15020 Clopper Road, Boyds
(HPC Case # 18/08-10B)
Boyd's Historic District

STAFF ITEM

SUBJECT: Revision to approved HAWP (Case 18/C8-10B), for demolition of a **Non-Contributing Resource** and construction of a new house, 15020 Copper Road, Boyds, a Non-Contributing Resource within the **Boys Historic District**

SUBJECT: Historic Area Work Permit #550313, demolition of non-contributing resource, construction of new house

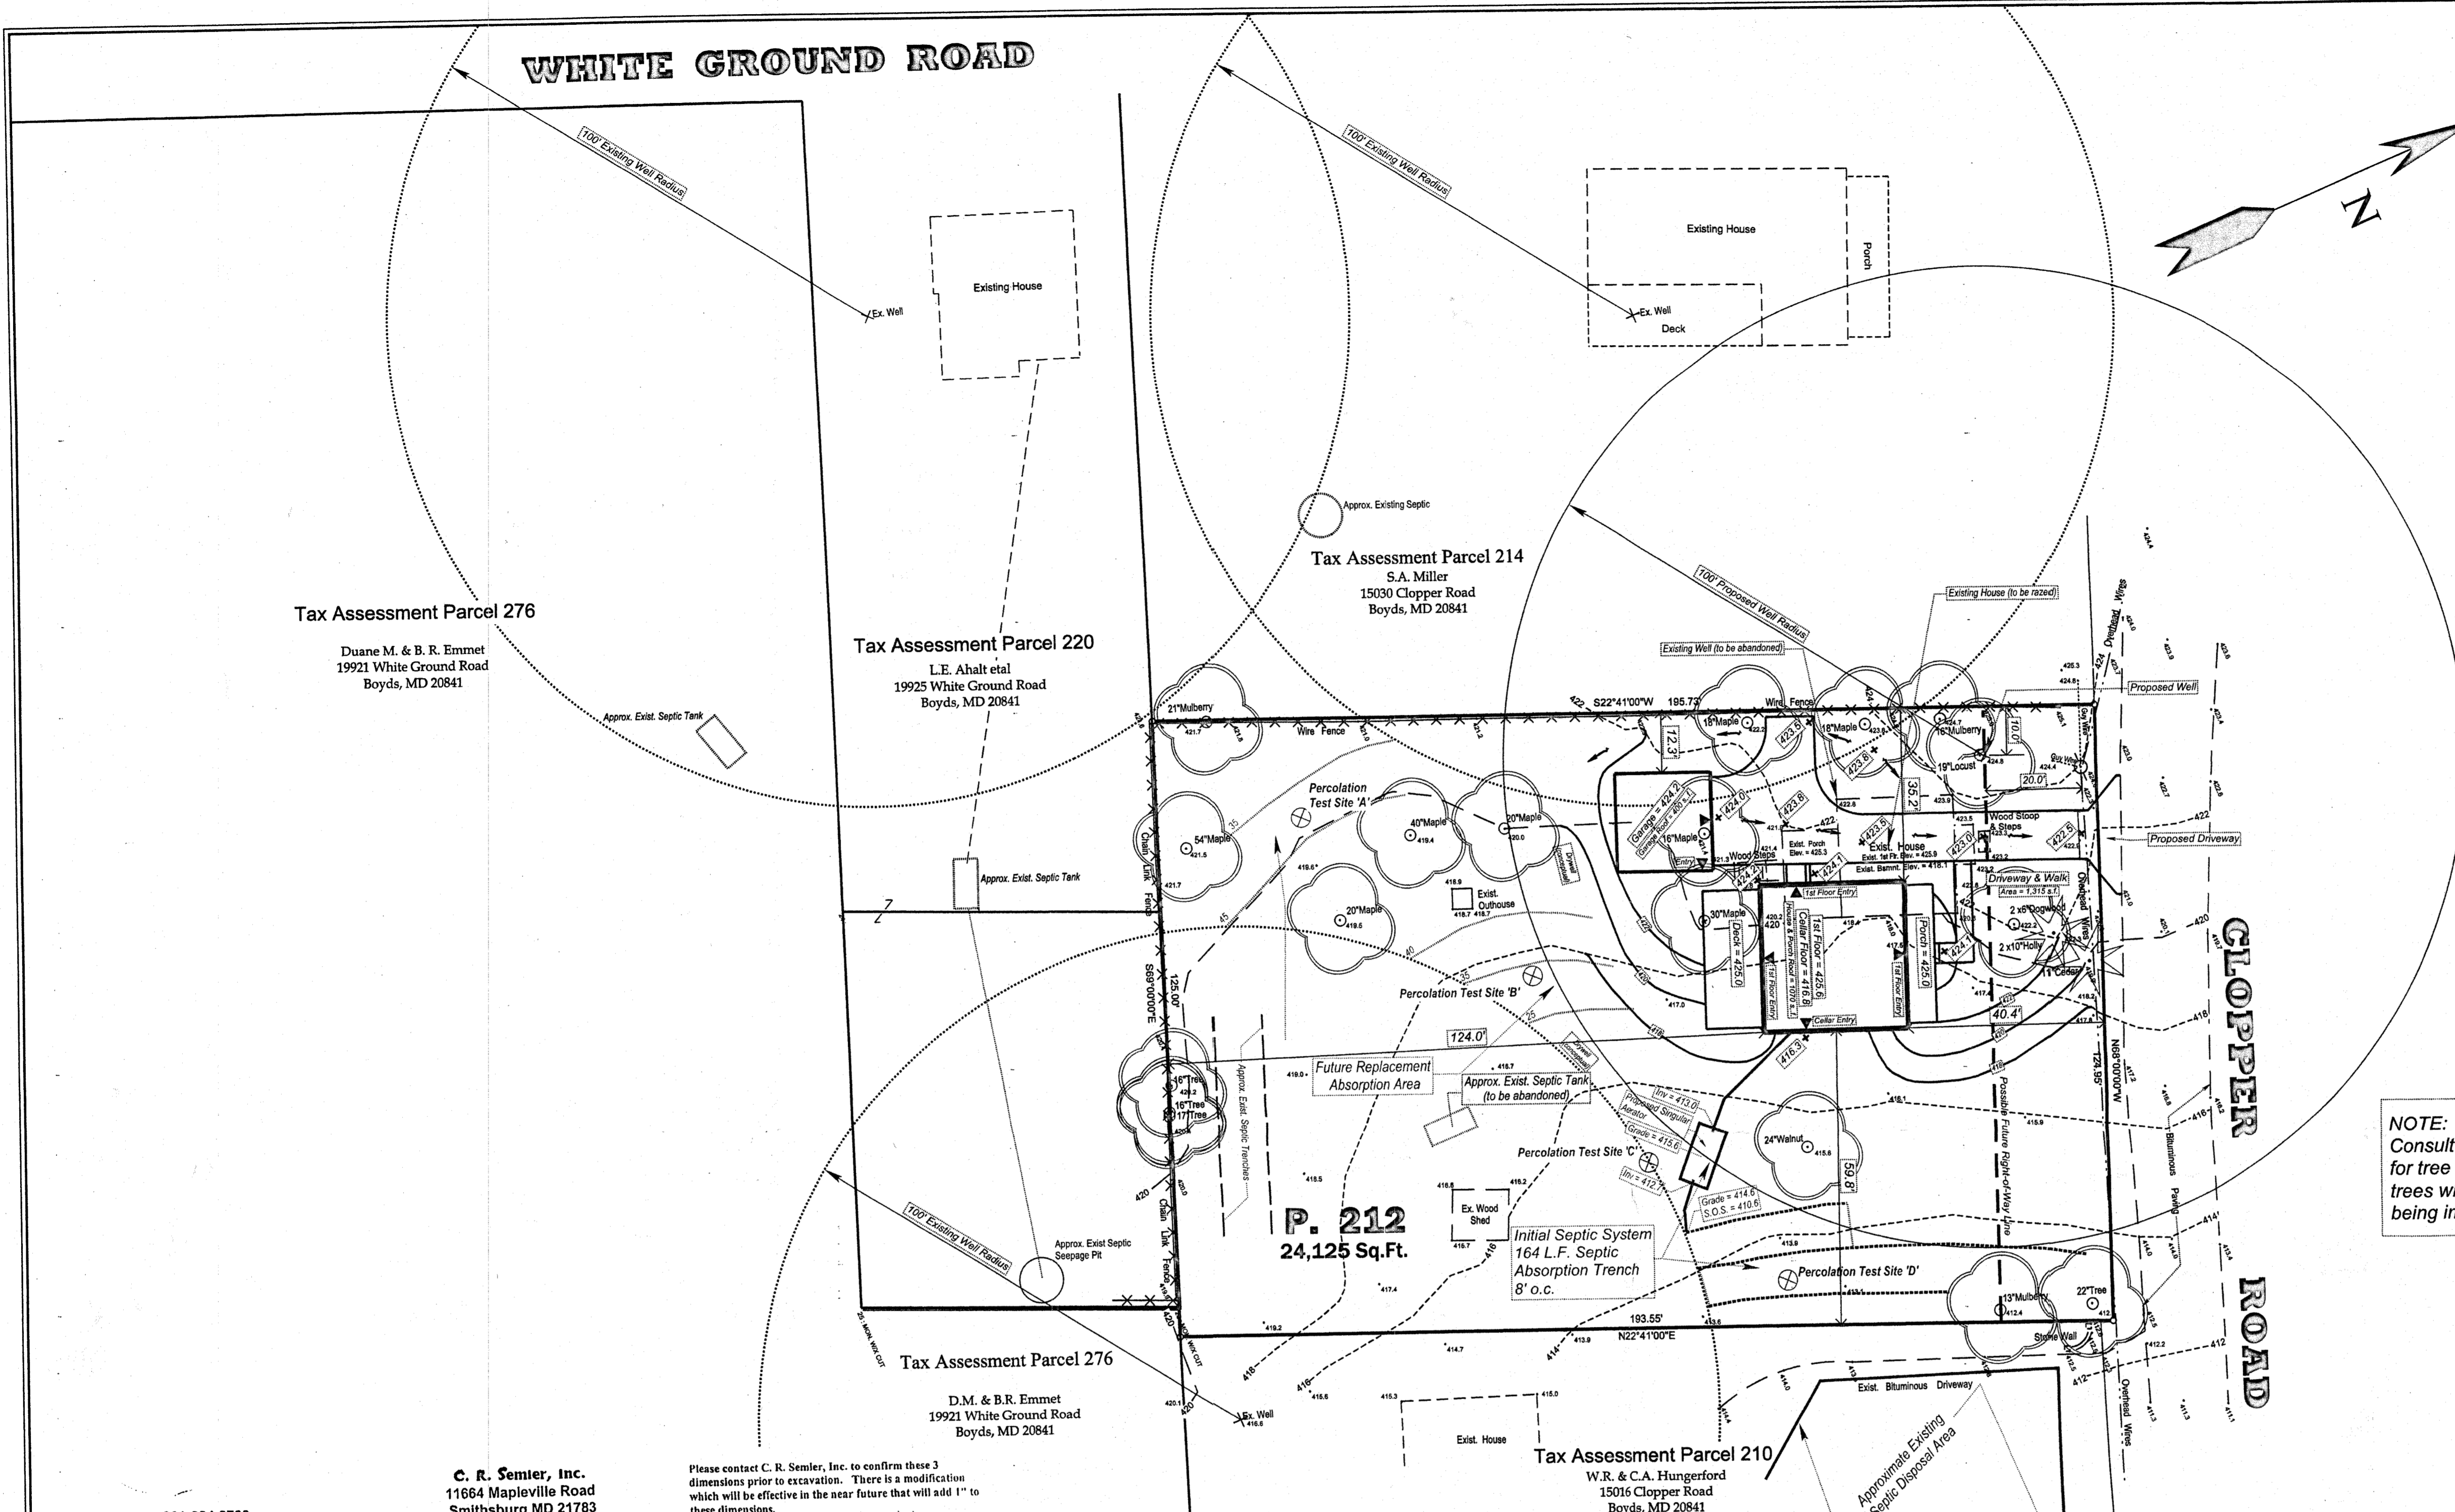
15 I think it would be helpful when you come back for
16 a HAWP to really look at a contour grading plan and really
17 accurately depict those contours around the house. I could
18 be wrong, but I suspect this is kind of oddball based on
19 what your best guess is or whoever drew this best guess on
20 what the contours would be there. But, I suspect they're
21 going to be, there's going to be more exposure to that
22 foundation wall than what we see in this drawing.

3 MR. KIRWAN: If you're going to do that, all the
4 more reason to bring a contour site plan with you for your
5 HAWP because I think we might have some concerns about the
6 environmental changes that will occur on that site if you're
7 bringing fill into the site, how much fill you bring in, how
8 much are you changing the natural contours there. So, I
9 think that's something we'll want to focus on too when we
10 see it next time.

13 MR. JESTER: If I could just add one more thing.
14 There was a comment by Commissioner Kirwan about, with a
15 request for a more detailed site plan and possible grading,
16 so that's a condition to be included with your HAWP when you
17 prepare it.

15020 Clopper Rd		
SCALE: 1/4" = 1'0"	APPROVED BY:	DRAWN BY:
DATE:		REVISED:
Front + Rear Elev		DRAWING NUMBER
		3 of 9

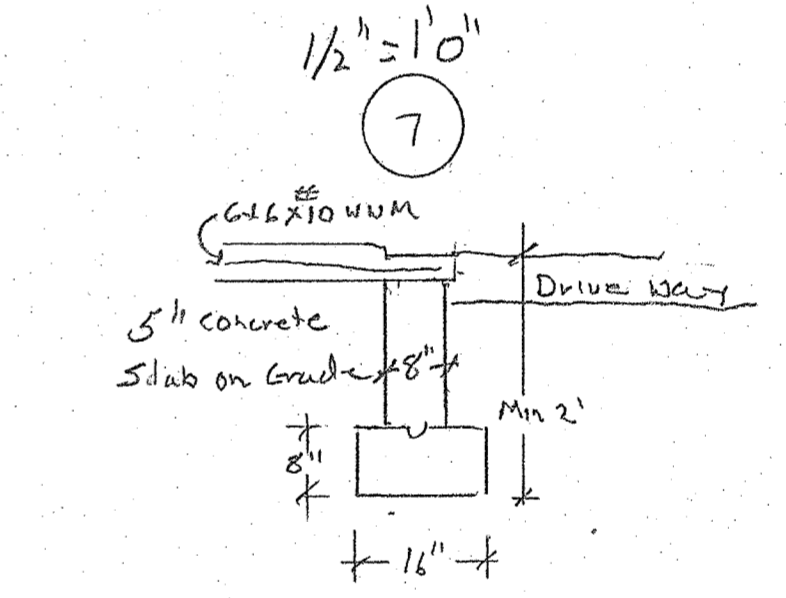
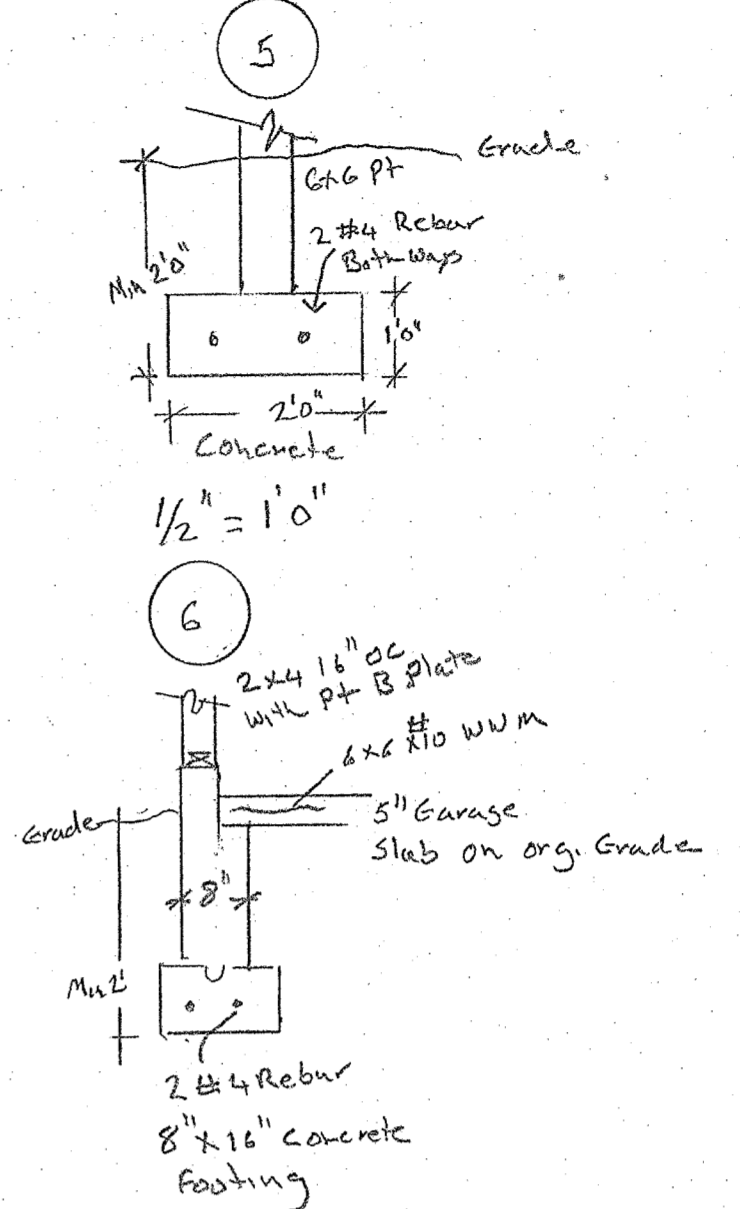
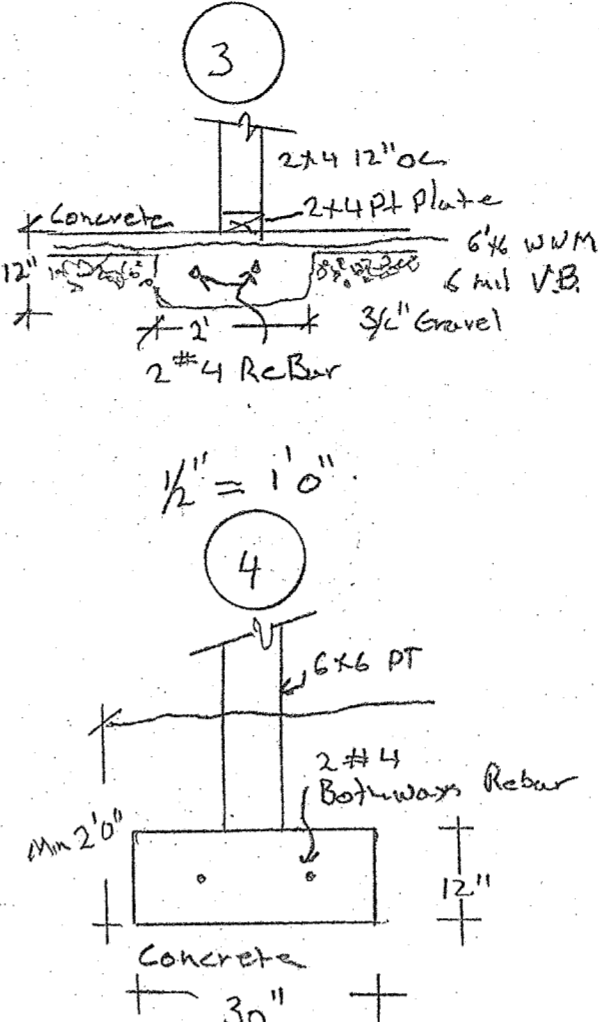
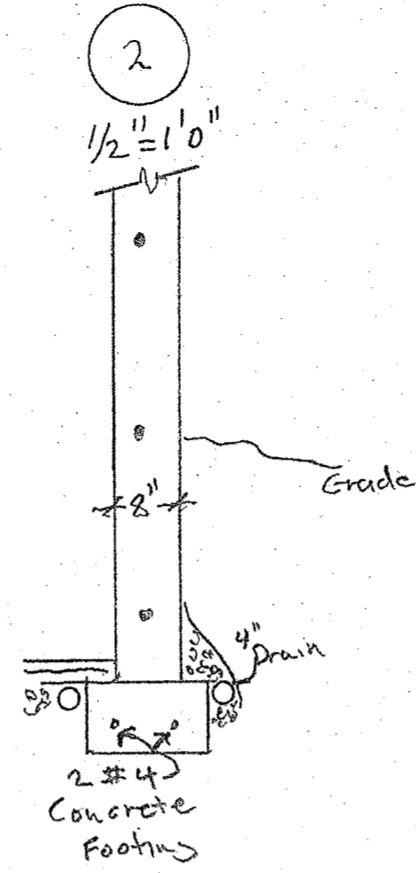
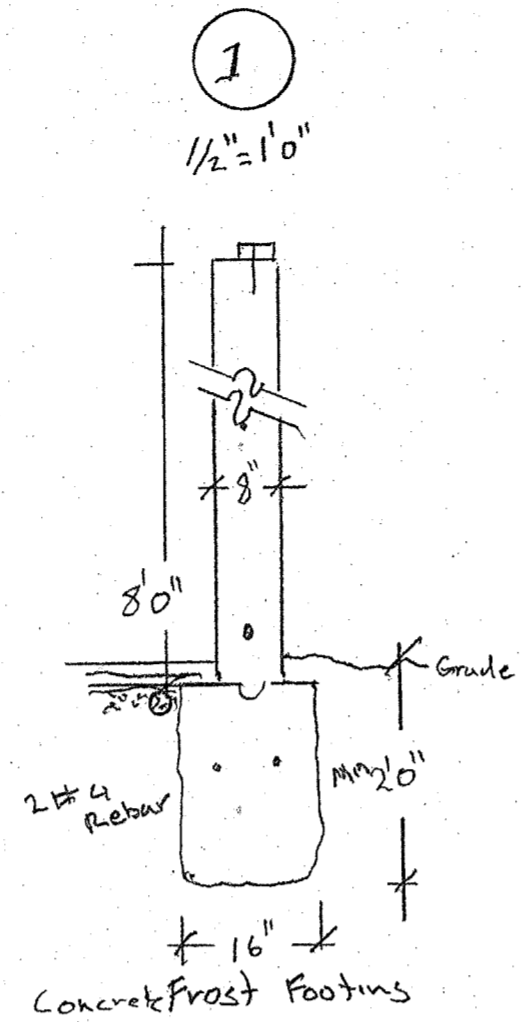
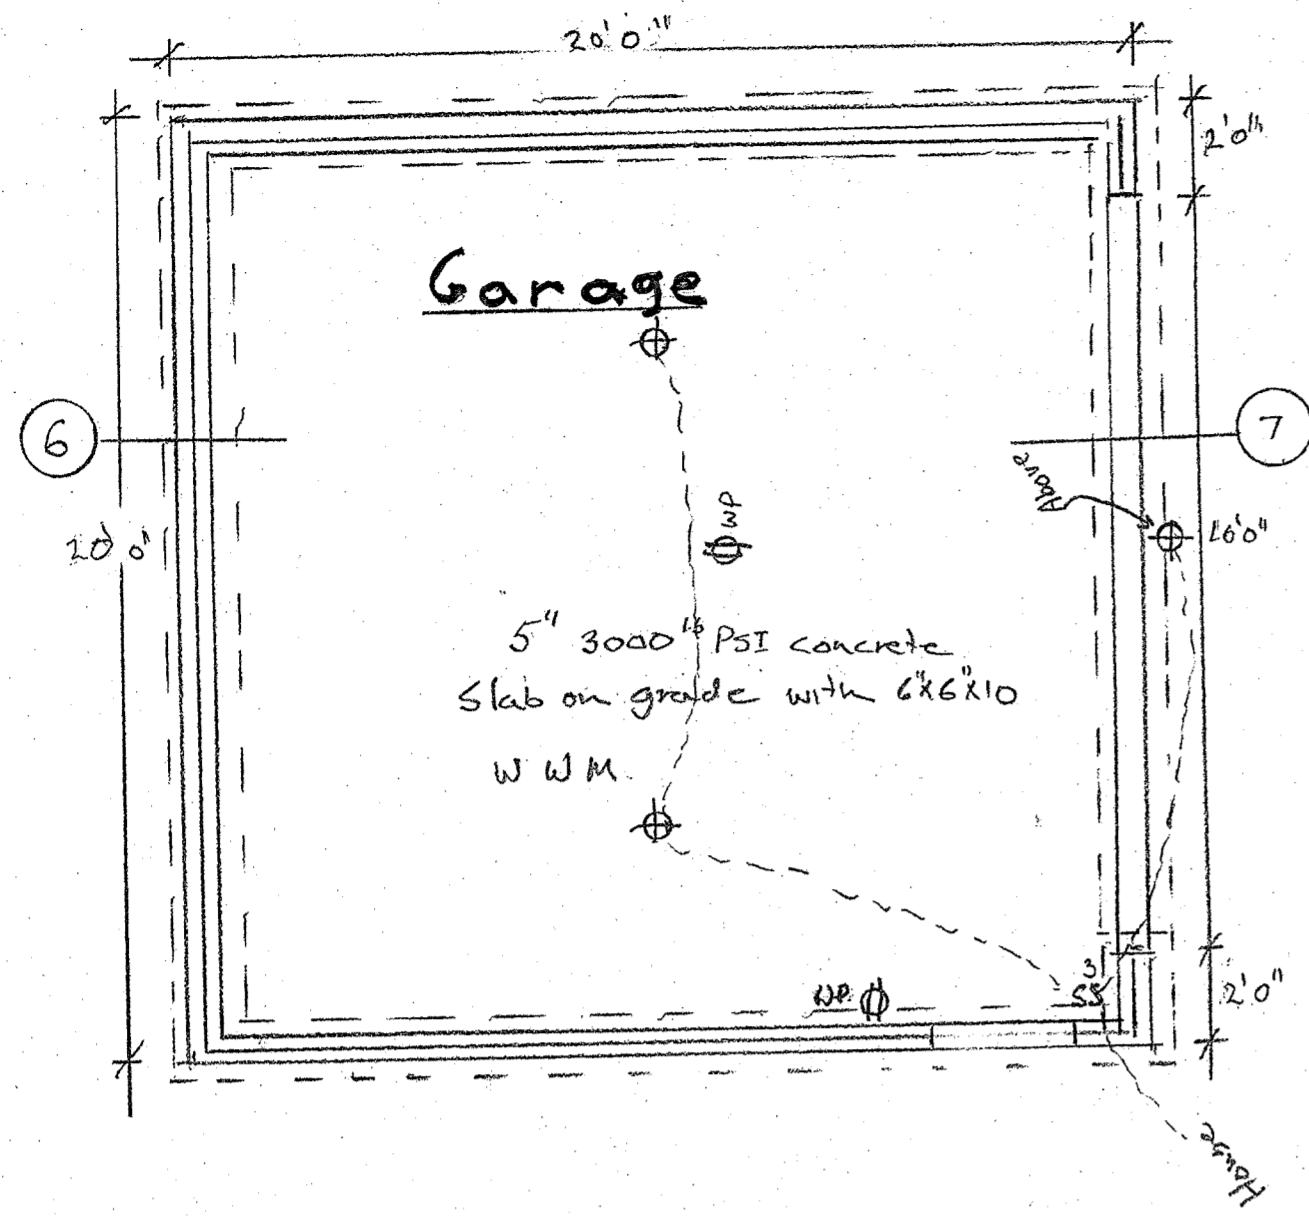
1. *The proposed garage door style is **not** approved. The applicant will install a carriage style or similar door in lieu of the proposed door. Final design to be reviewed and approved by HPC staff.*

**Rear Elevation
Showing Added Bay Window
And Chimney on Right**

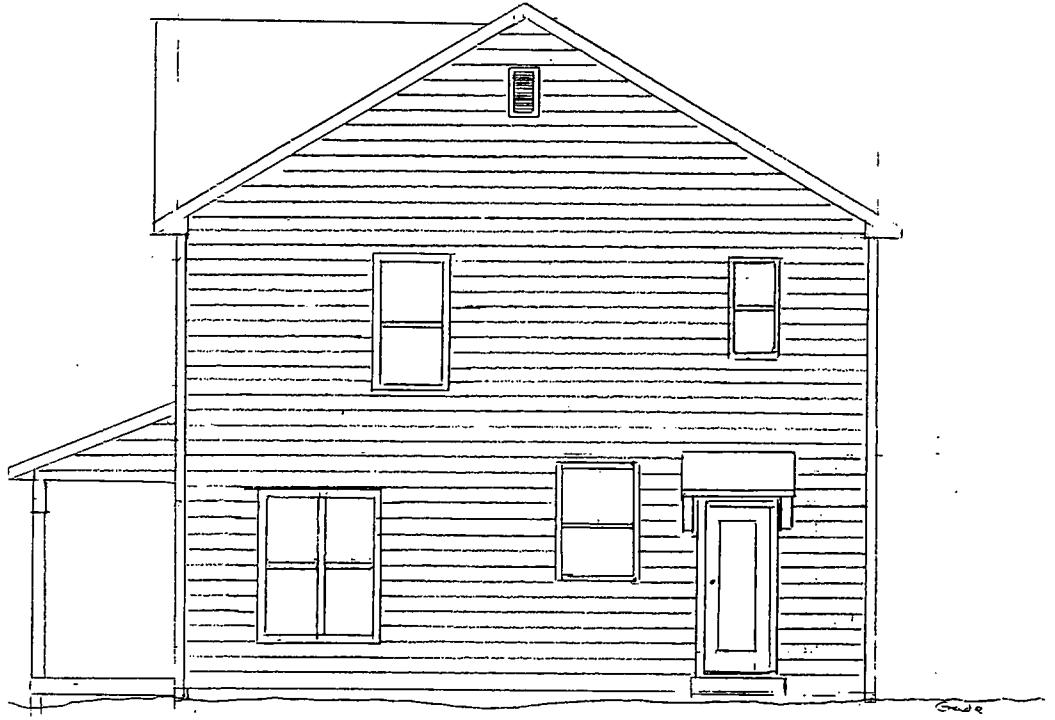
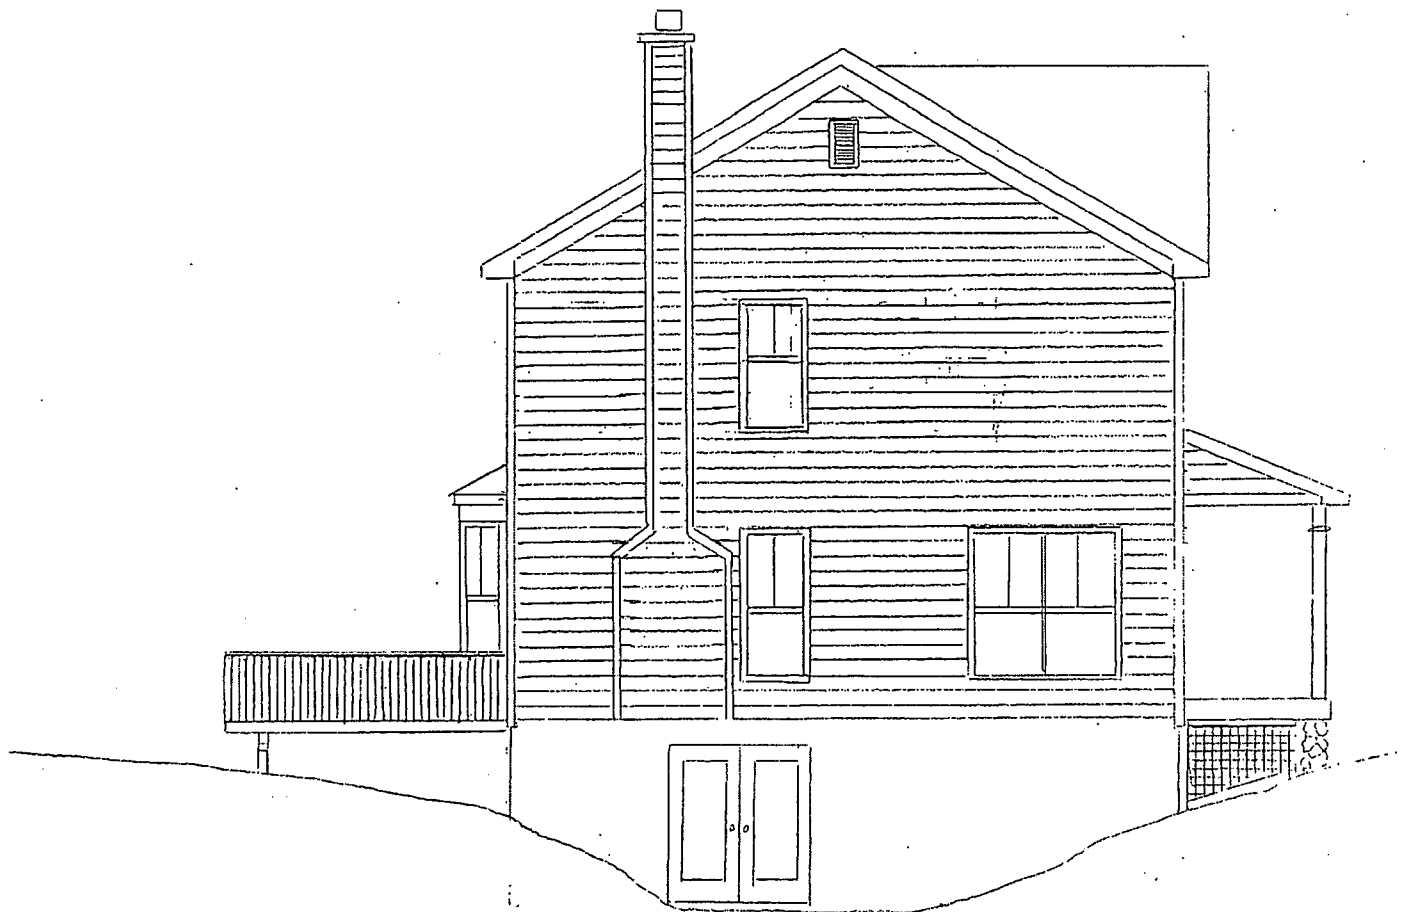
REVISED PROPOSAL: The applicant is requesting approval to install a bay window in lieu of the approved double-hung windows at the rear elevation.

The applicant is also requesting approval to install an external box chimney clad in fiber cement siding on the left side elevation.

STAFF RECOMMENDATION: Staff is recommending that the HPC approve the bay window addition in lieu of the approved double-hung window. The proposed alteration is confined to the rear elevation of a new house, as such it will have negligible impact on the streetscape of the historic district.

Staff does not support the revised proposal to install a fiber cement external box chimney on the left side elevation. The proposed chimney design and materials are incompatible with the style and materials of other masonry chimneys found within the Boyds Historic District. Staff finds the proposed installation of a external box chimney clad in fiber cement siding to be *inconsistent* with Chapter 24(b)(2), which states:

Staff recommends approval of the bay window. Staff recommends that the HPC deny the applicants request to install an external box chimney clad in fiber cement on the left elevation.

APPROVE BAY WINDOW ✓
DENY CHIMNEY INSTALLATION
